REVIEW AND EVALUATION OF RECENT PUBLICATIONS BEARING
ON THE FUELS SECTIONS OF THE DRAFT MHTGR PSER.

OAK RIDGE NATIONAL LABORATORY

Technical Evaluation Report

February 10, 1993

Fig. 3.4-1. TRISO irradiation data base extends far beyond MHTGR service conditions.

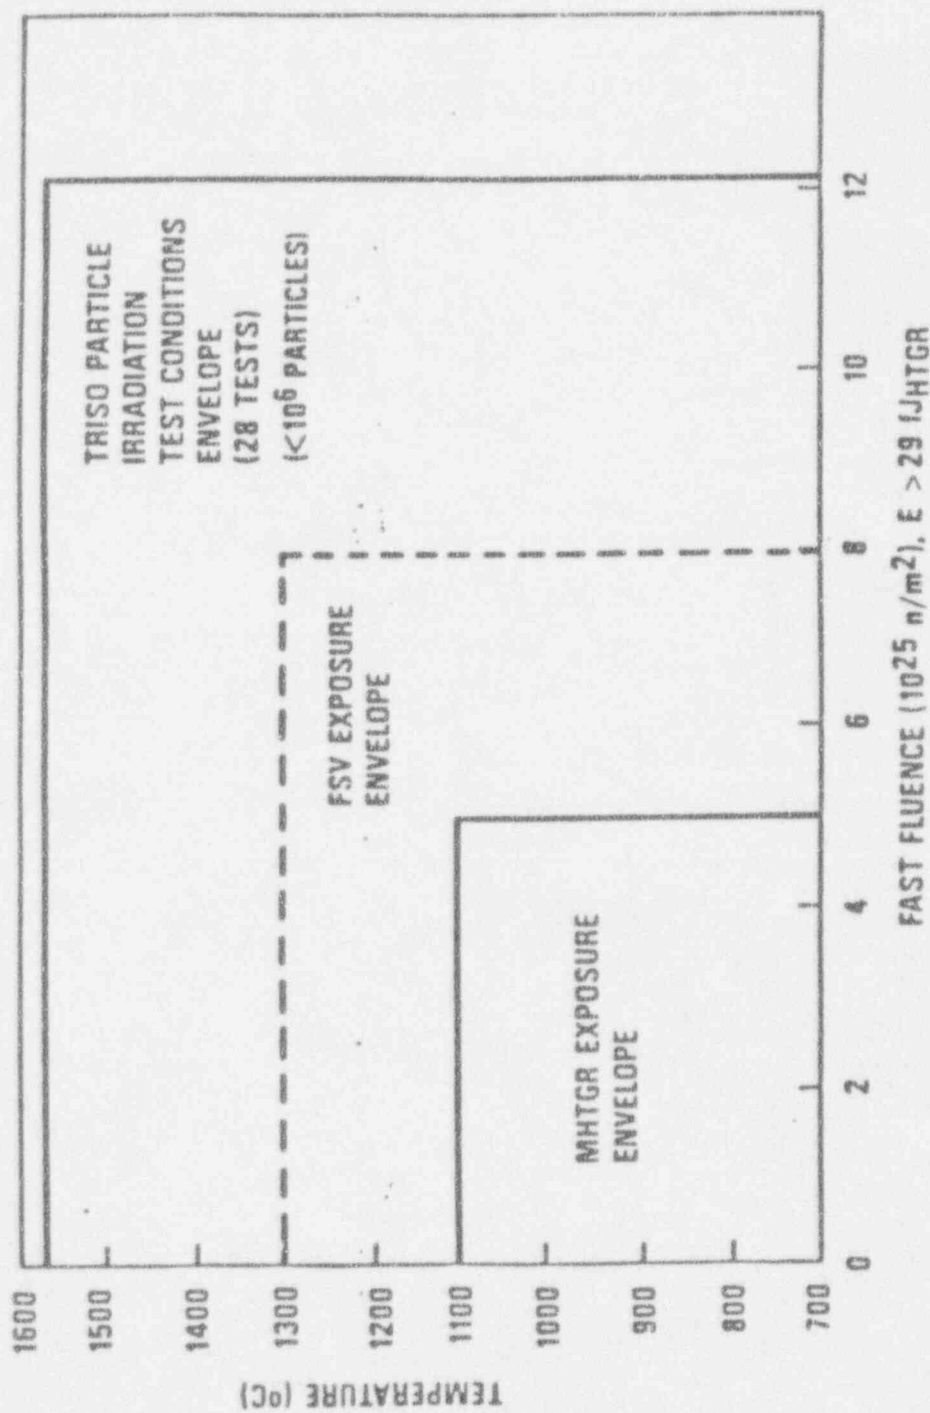
Figure 3.4-1 illustrates that the current MHTGR design has succeeded in reducing the normal operations exposure envelope of the fuel relative to both the LSV experience and the range of test capsule conditions, at least in terms of temperature and fast fluence.

Fig. 3.4-2. TRISO irradiation data base includes irradiation and operating reactors.

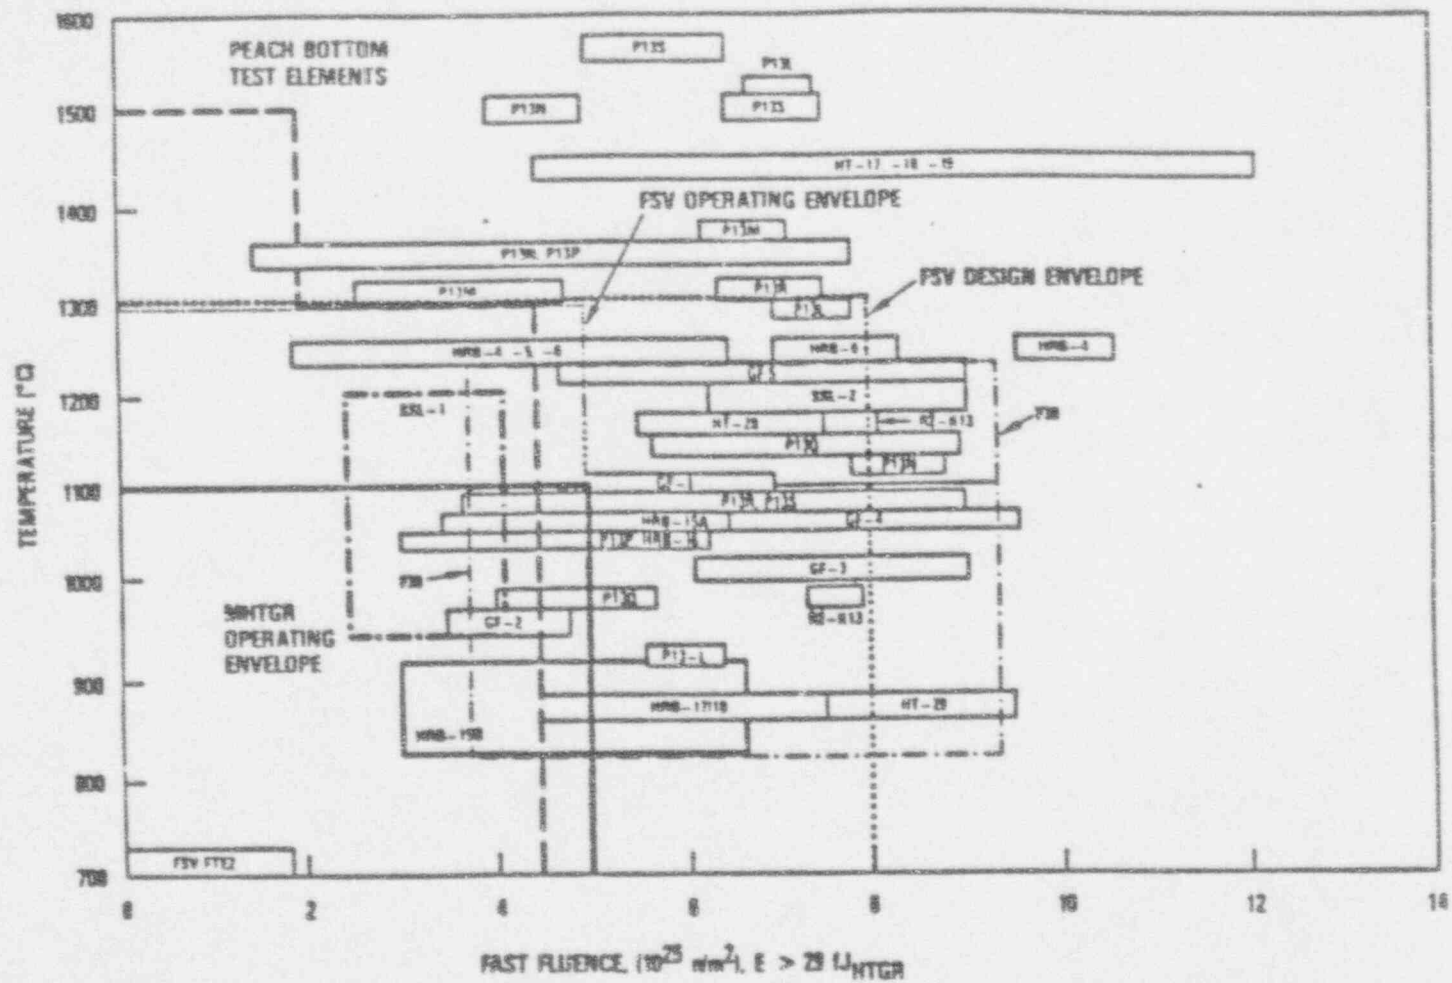
Figure 3.4-2 presents a useful summary of fuel irradiation test history including both German and U.S. test capsules. The intended impression is that the small MHTGR operating envelope has been well covered by numerous test capsules that go well beyond in fluence and temperature conditions. However, many types of fuel are included, both loose particles and in compacts. Also some of the capsules were intended for accident conditions; therefore, the accident conditions envelope should also be shown.

Fig. 3.4-3. Circulating activity measurements indicate that performance models based on accelerated testing are conservative.

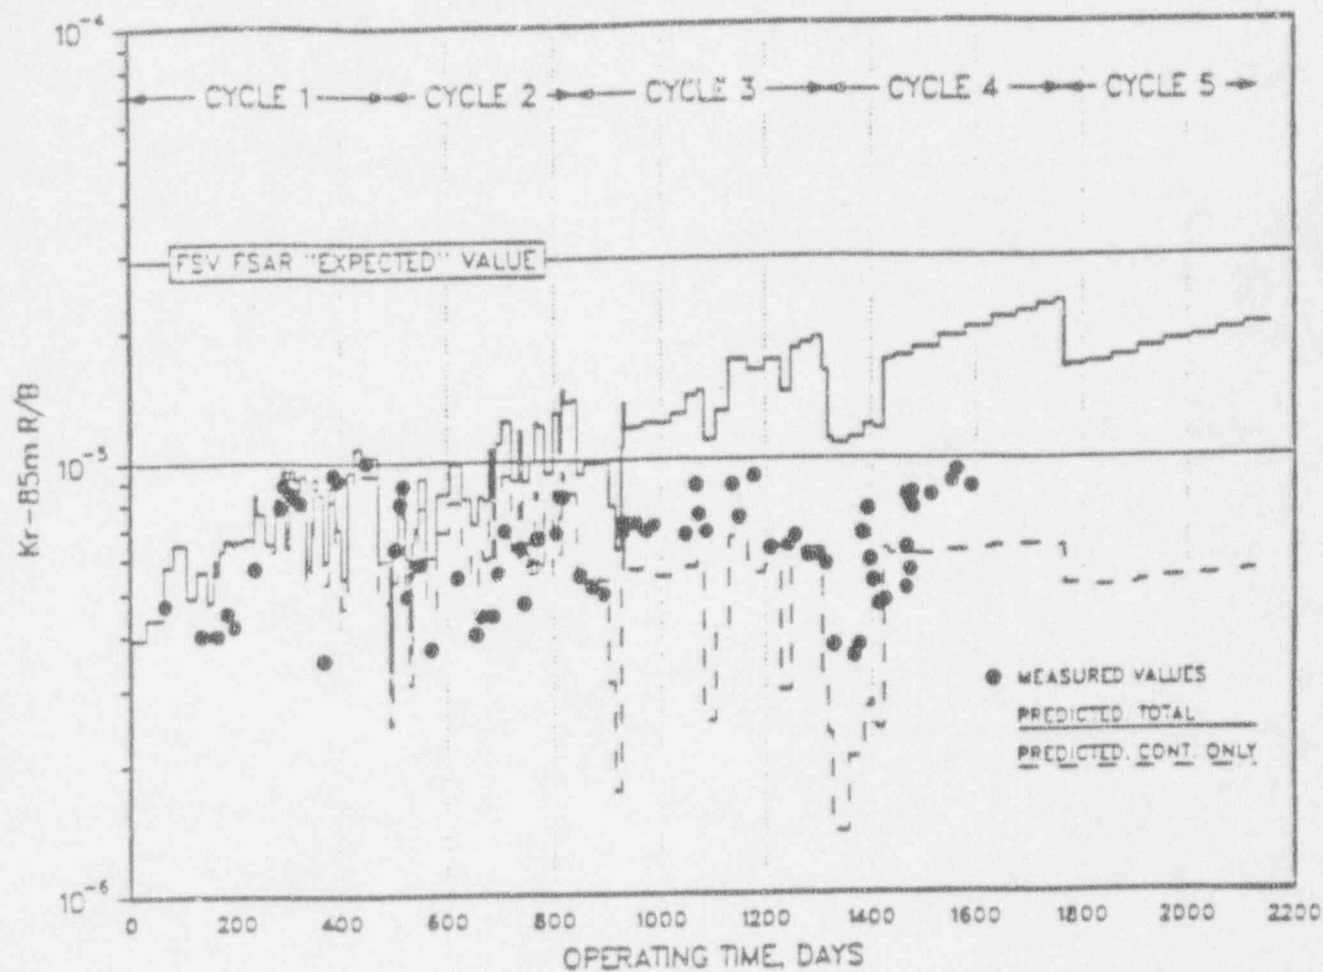
Figure 3.4-3 illustrates that radioactivity retention by FSV fuel, during this time period at least, was better than both model predictions and the "expected" release rate cited in the FSV FSAR.

Fig. 3.4-4. FRG ramp tests to 2500°C show TRISO fuel contains radionuclides beyond MHTGR maximum conditions.

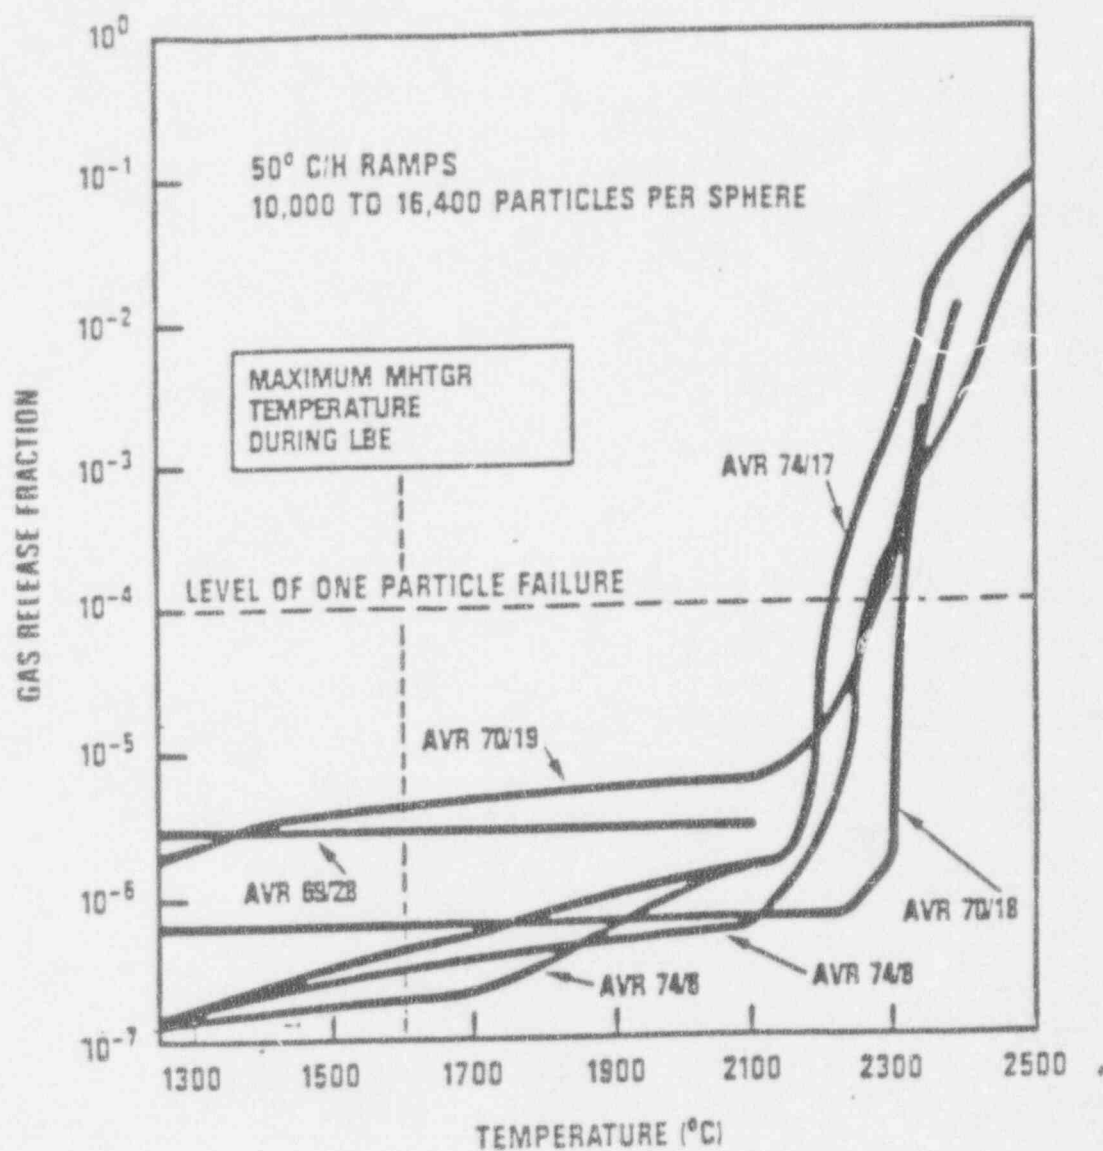
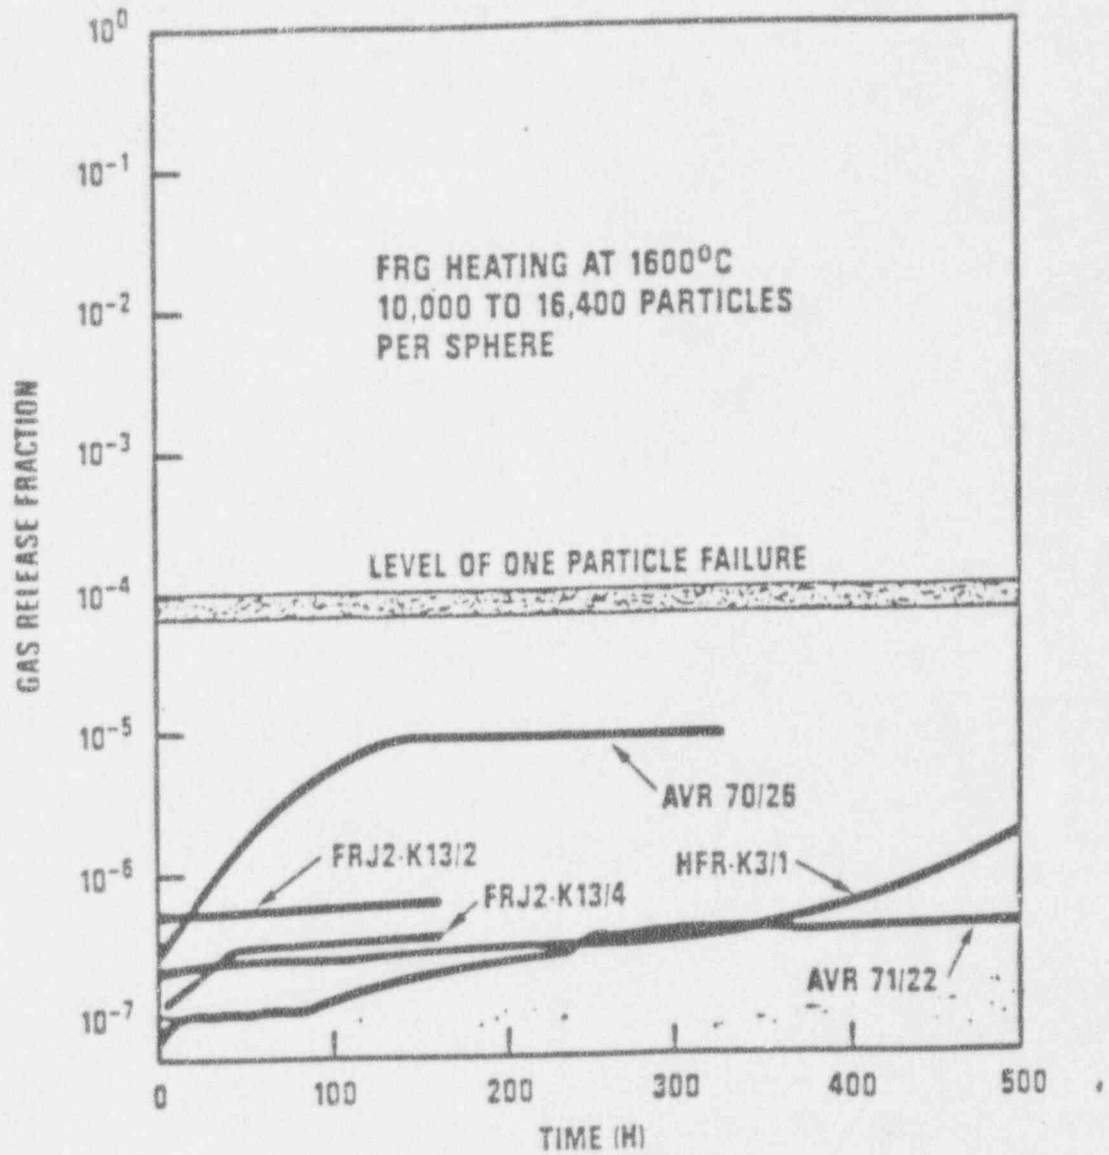
Figures 3.4-4 and 3.4-5 illustrate the superior performance of fuel particles in German spherical fuel elements under two sets of simulated accident conditions: (1) temperature ramp tests up to 2500°C which show no particle failures below 2100°C, and (2) annealing tests which show no particle failures at up to 500 h of heating.
